Determination 2019/022

Regarding the decision to issue a code compliance certificate in respect of surface water drains to a house at 17 Flavell Street, Heathcote Valley, Christchurch

Summary

Figure 1: The surface water drainage system taken from the amended drainage plan⁵ dated 1 October 2015 (not to scale)

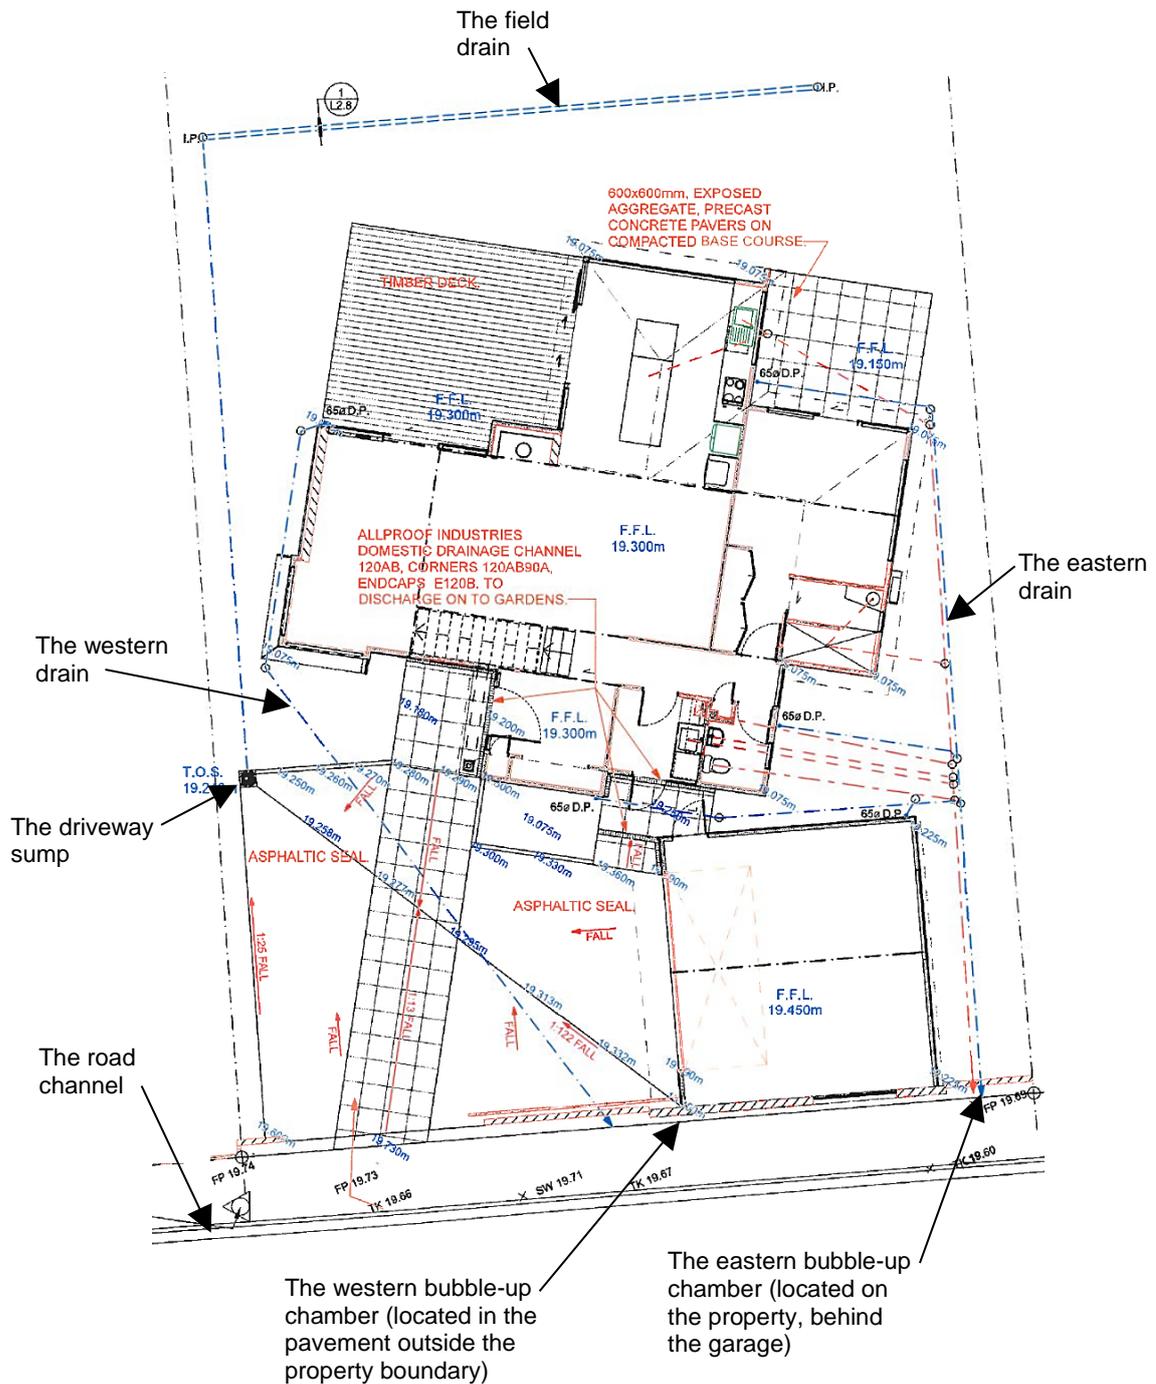
5.2.3 The observations of the expert and the drainage inspection videos confirm that the western drain is damaged (refer to paragraphs 4.3.1 to 4.3.4) and is leaking to a significant extent. The western drain is not conveying the surface water to an appropriate outfall, as required by Clause E1.3.3(a) and (c). (I note the western bubble-up chamber is located outside the property boundary.)

5.2.4 I am therefore of the view that at the western drain does not comply with Clause E1 of the Building Code.

5.2.7 The expert found the eastern and western bubble-up chambers had not been built as detailed in the revised drainage plan, which show a solution taken directly from E1/AS1, (refer to paragraph 2.2.7) because of the chambers’ diameter, depth, depth of the inlet invert, and silt capacity (refer to paragraph 4.5.1).

- 5.2.12 The as-built system does not meet these provisions. However, while each individual bubble-up chamber has less capacity than the solution described in E1/AS1, the as-built system is configured with two separate bubble-up chambers serving the house, whereas E1/AS1 describes a solution with only one bubble-up chamber.

5.2.21 The expert found the driveway sump had not been built to meet the provisions of E1/AS1, as shown in the revised drainage plan (refer to paragraph 2.2.7) because of the diameter of the sump and the configuration of its outlet.

- the as-built surface water system does not comply with Clause E1 in respect of the western drain, because the drain is damaged
- the as-built surface water system complies with Clause E1 in respect of the eastern drain, the eastern bubble-up chamber, the western bubble-up chamber, the driveway sump and the field drain.

- the surface water system does not comply with Clause E1 of the Building Code in respect of the western drain
- the surface water system complies with Clause E1 of the Building Code in respect of the eastern drain, the eastern and western bubble-up chambers, and the driveway sump and associated field drain
- the authority incorrectly issued a code compliance certificate in respect of the surface water system, and accordingly, I reverse that decision.
